La Vergne Planning Commission
September 24, 2024 at 5:30 PM

Planning Commission Report Meeting: September 24, 2024	City of La Vergne

C-0.0	COVER SHEET
C-1.0	EXISTING SITE LAYOUT
C-2.0	SITE PLAN
C-3.0	CIVIL DETAILS
A-1.0	ELEVATIONS

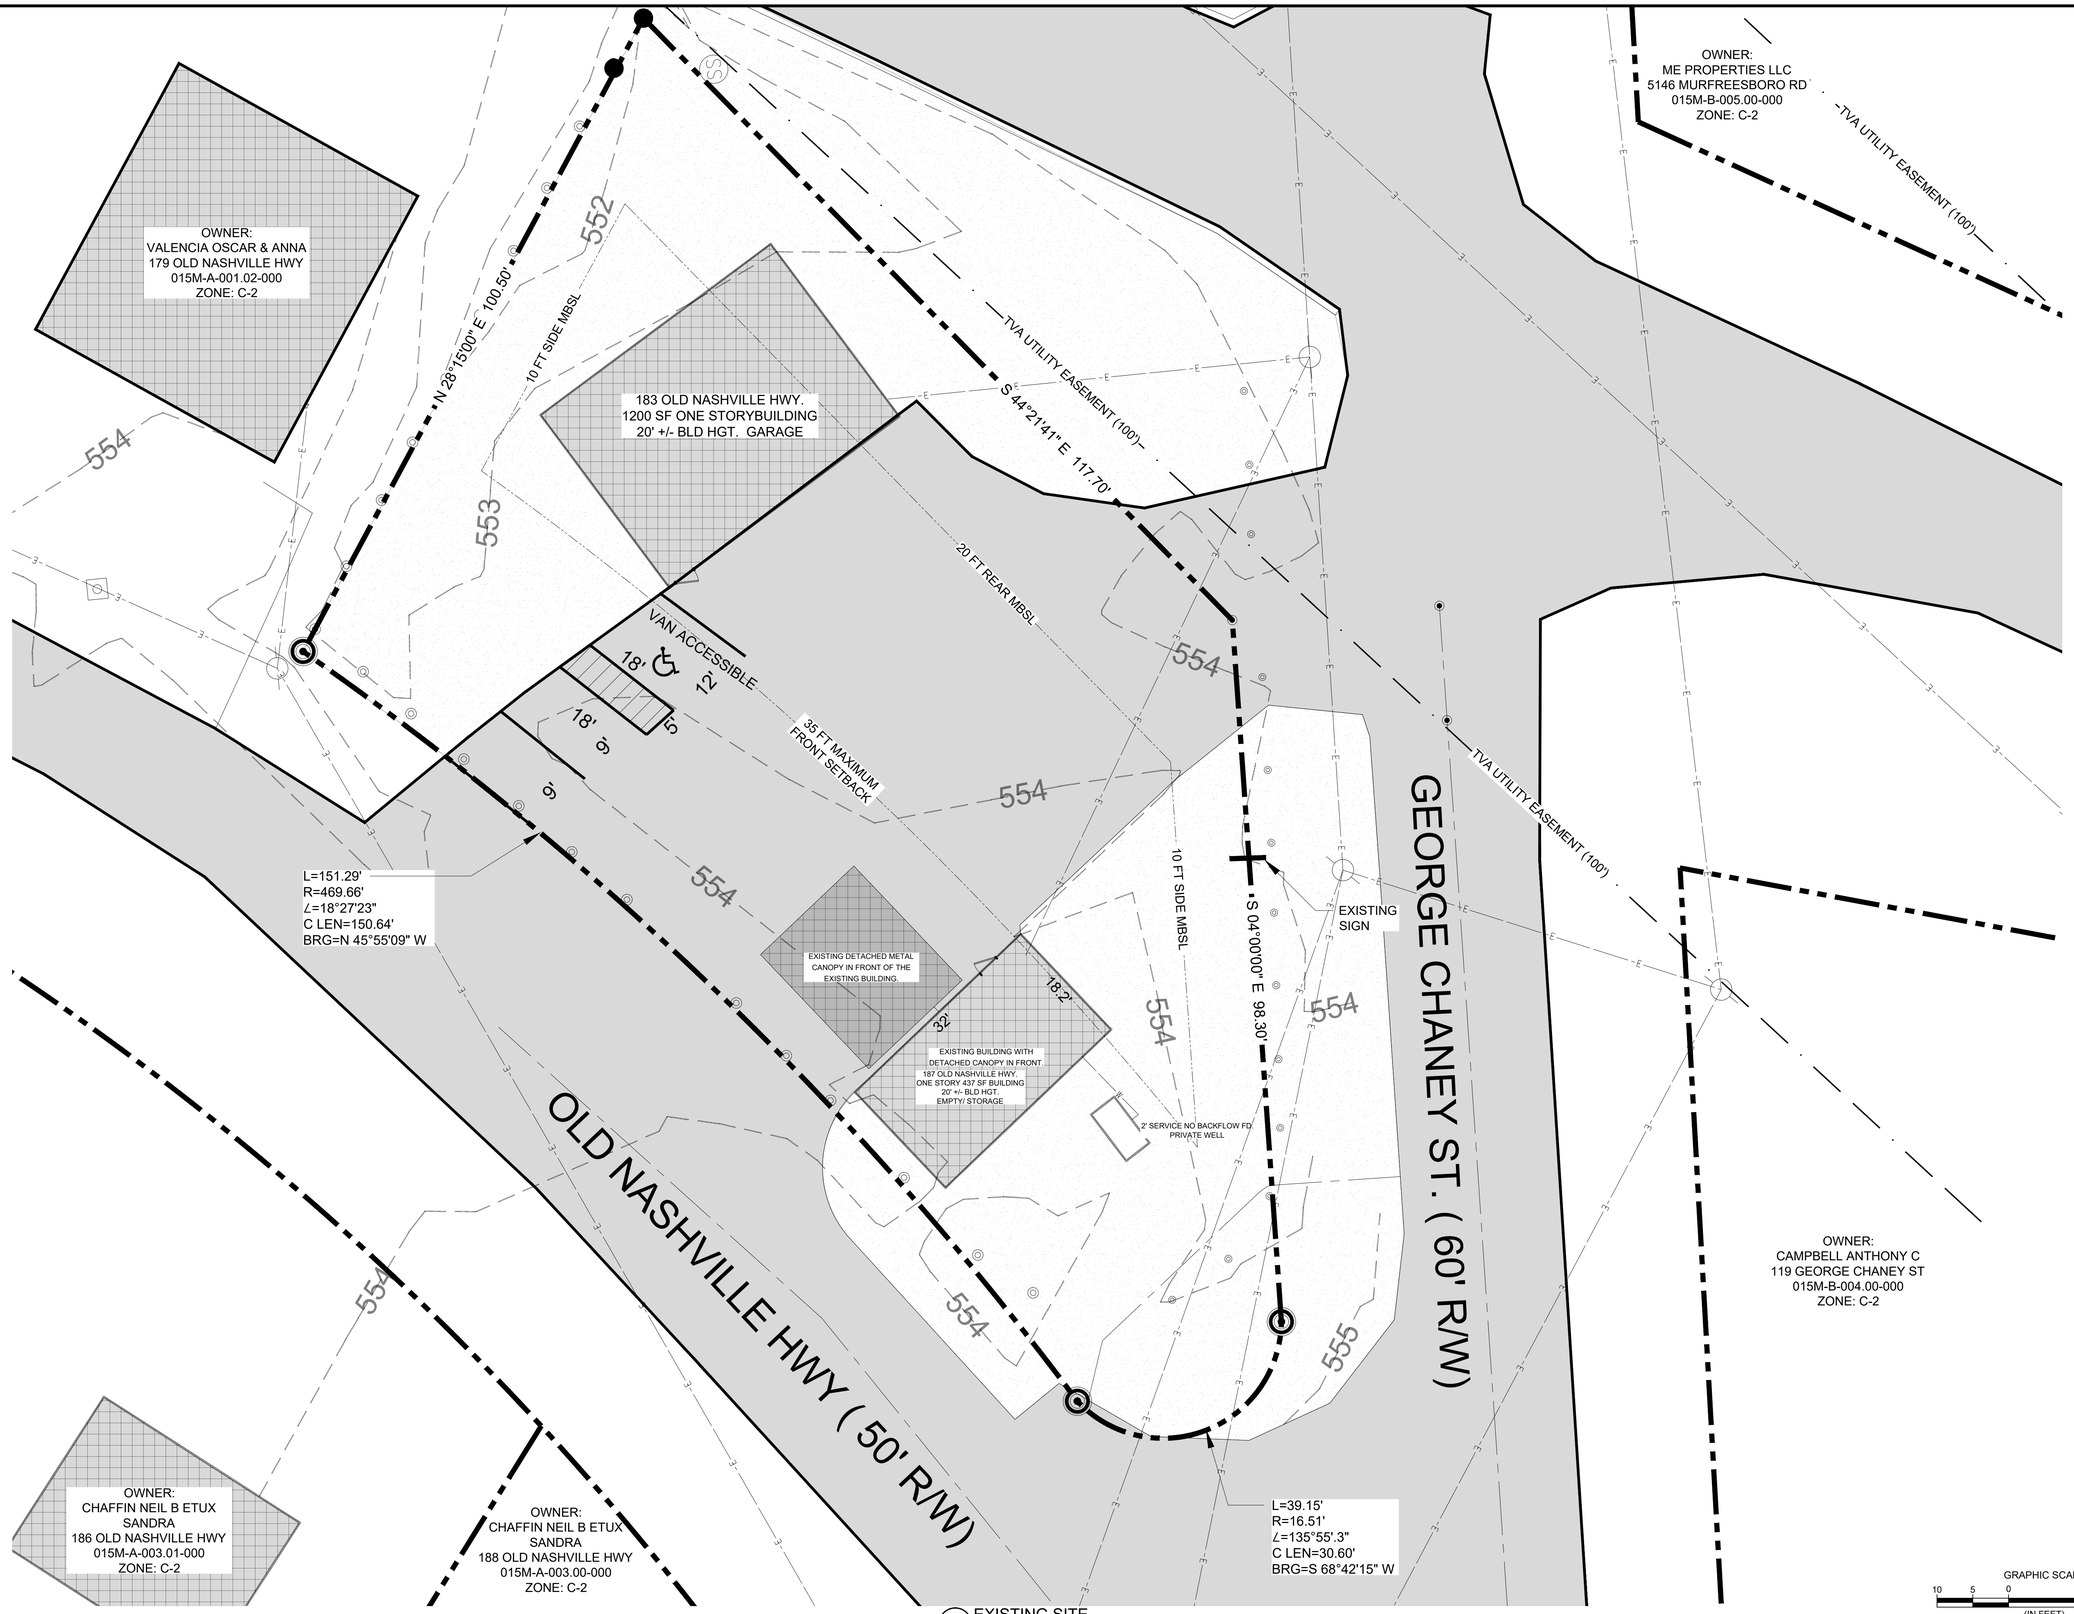
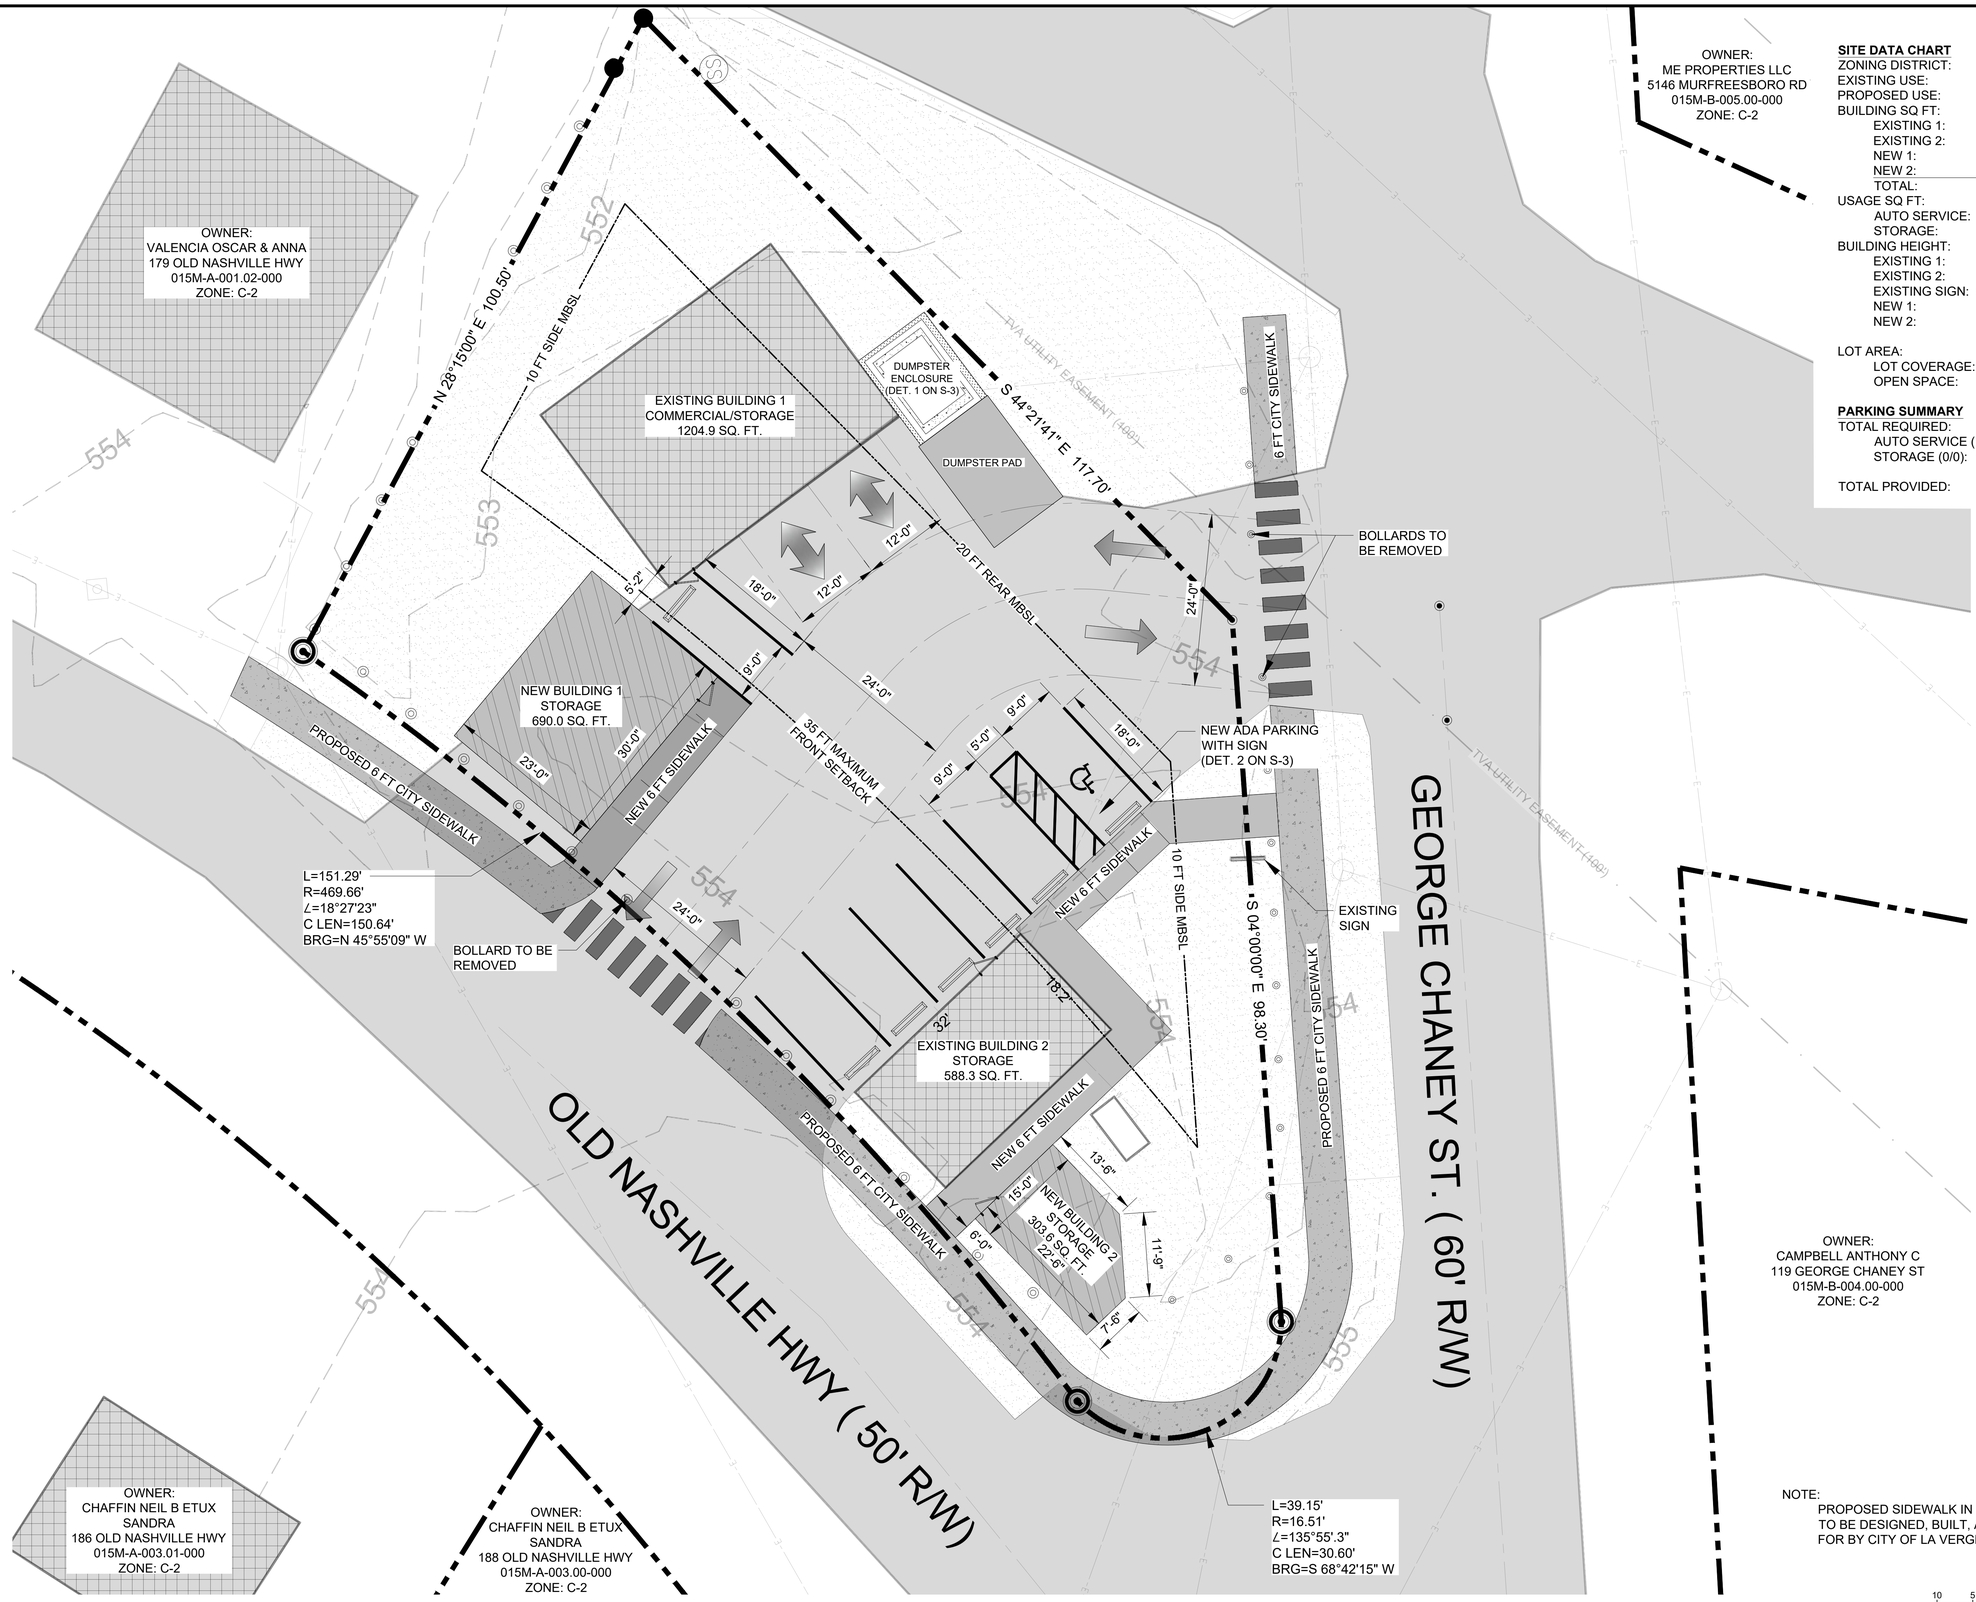
1. Show outline of existing building on sheet A-1.1 for clarity.
2. Provide information regarding construction methods for proposed building (i.e. is the existing building going to be demolished, gutted, or is this an addition?)

SHEET
C-3.01
REV.

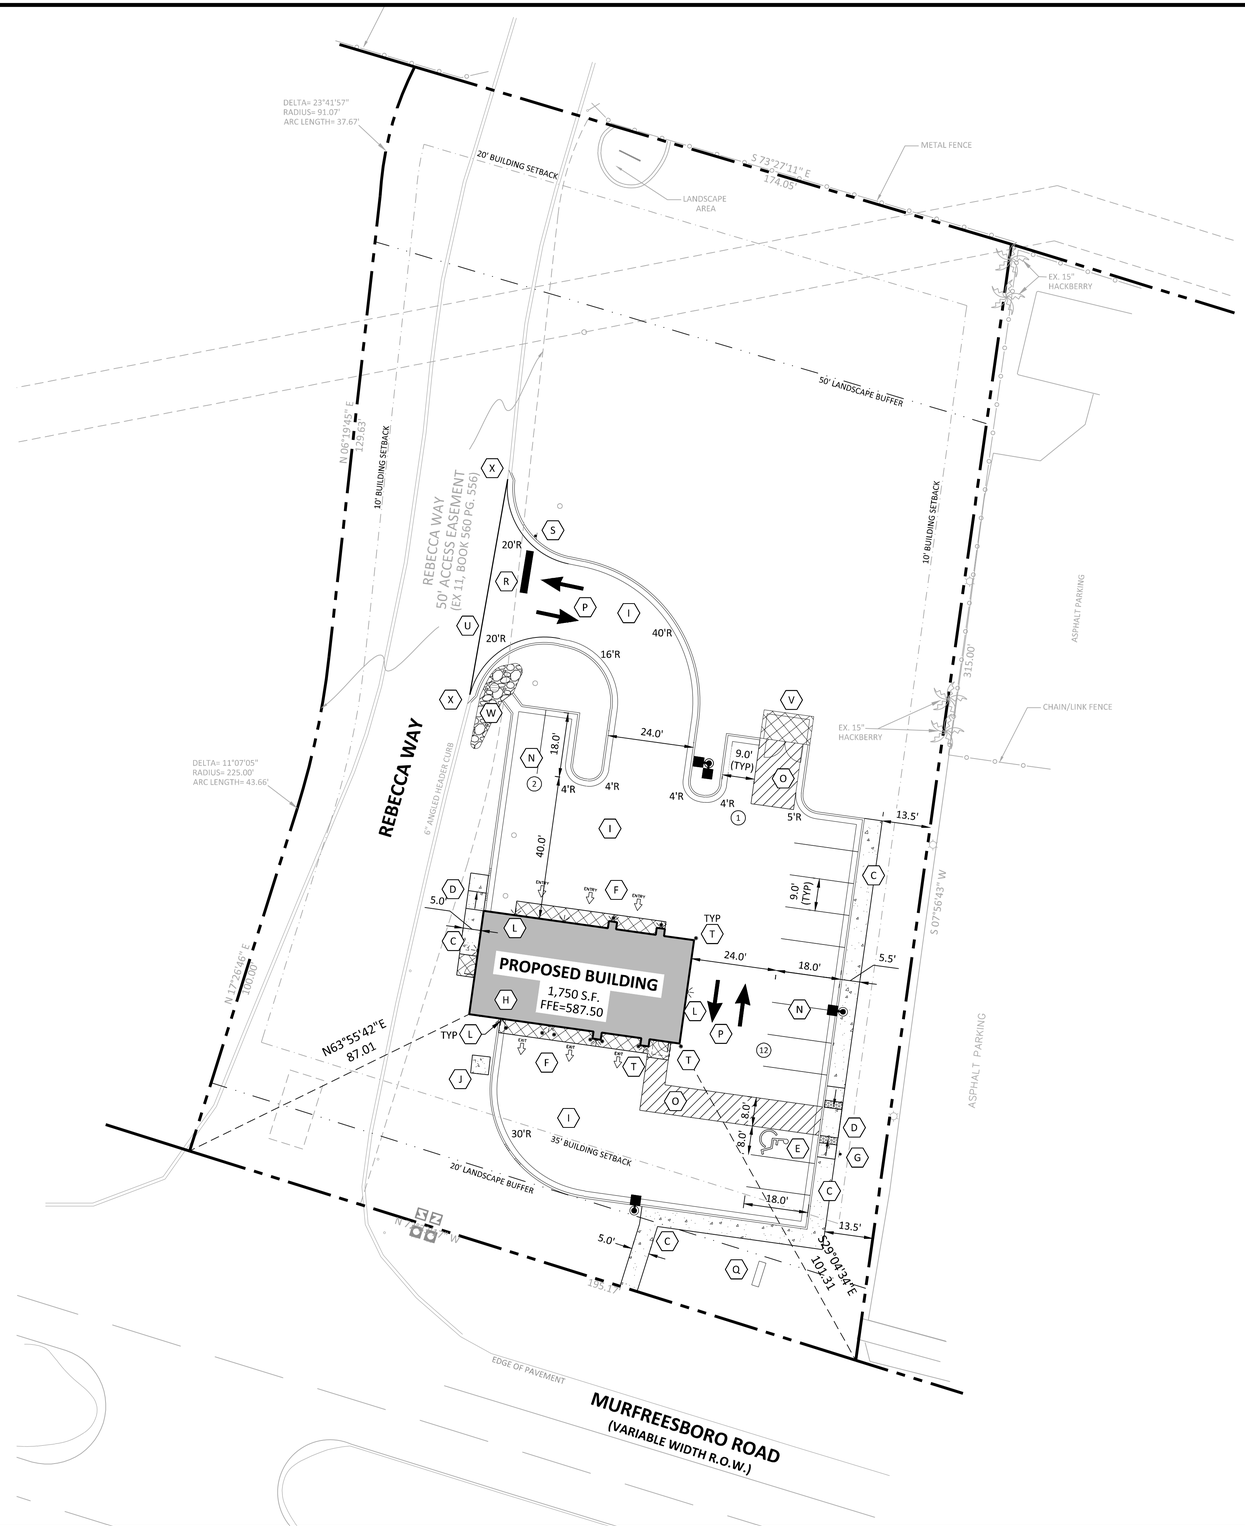
3. Provide a draft Long-Term Maintenance Plan (LTMP) for review. Format is at the discretion of the Engineer. City review checklist has been provided.
4. (Sheet C-3.01) Provide distance from southern point "X" at driveway entrance to Murfreesboro Road right-of-way.
